Subject: Perpendicular Aluminum Air Tank Mounting Brackets

Models Affected: Specific Freightliner 114SD, Business Class M2, Cascadia, and Coronado vehicles; Sterling 9500 vehicles; and Western Star 4700 vehicles manufactured July 30, 2008, through December 15, 2011.

FL631

INTERIM RECALL BULLETIN

Fig. 1, Inspecting for Cracks

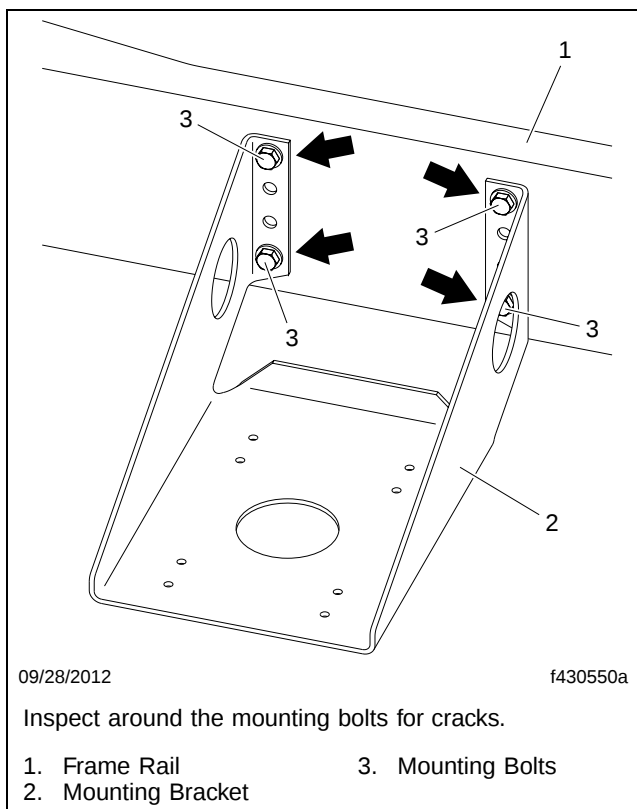
1. Park the vehicle on a level surface, shut down the engine, and set the parking brake. Chock the tires.
2. Inspect each air tank mounting bracket for evidence of cracks in the vicinity of the bracket-to-frame mounting bolts. See **Fig. 1**.

Peeling or chipped paint, and/or discoloration or staining on the aluminum bracket may indicate small, hard to see cracks.

If there is any evidence of cracks, immediately (before putting the vehicle in service) take the vehicle to an authorized Daimler Trucks North America dealer for replacement with a steel bracket.

Fig. 2, Perpendicular Air Tank Installation

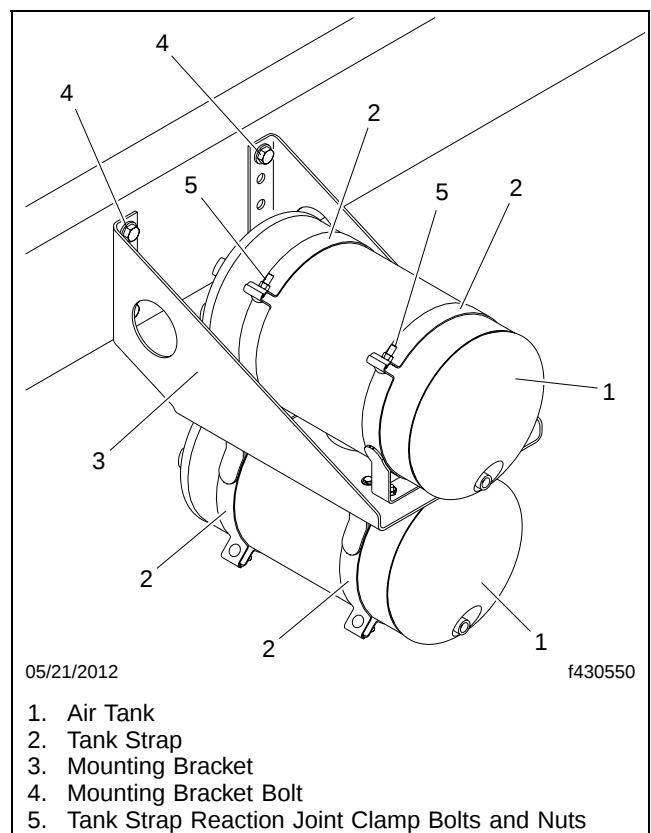
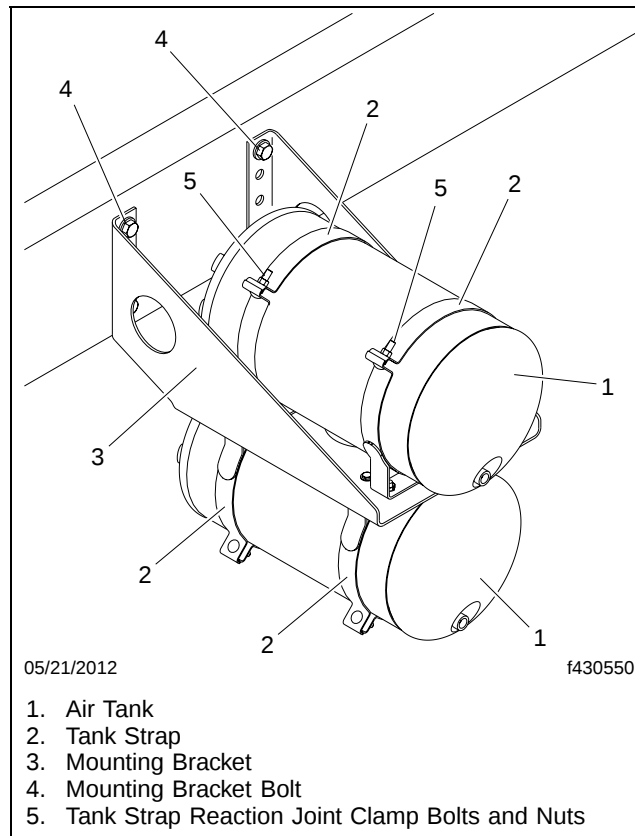
Refer to **Fig. 2** for this procedure.

- 6.4 Raise the corner of the battery box to access the bracket fasteners.
7. Remove the aluminum air-tank mounting bracket from the frame rail.
8. Install the new steel air-tank mounting bracket on the frame rail. Tighten the mounting bolts and nuts 120 to 150 lbf·ft (163 to 203 N·m).

9. Lower the battery box, and install the fasteners. Tighten 120 to 150 lbf·ft (163 to 203 N·m).
10. Install the batteries and the battery box cover.
11. Remove the air tank cradles from the aluminum air tank mounting bracket and install them on the new steel bracket. Tighten the mounting bolts and nuts 25 to 31 lbf·ft (34 to 42 N·m).

12. Position the tanks in the cradles on the new mounting bracket and install the straps and fasteners. Tighten the reaction joint clamp bolts 26 lbf·ft (35 N·m).
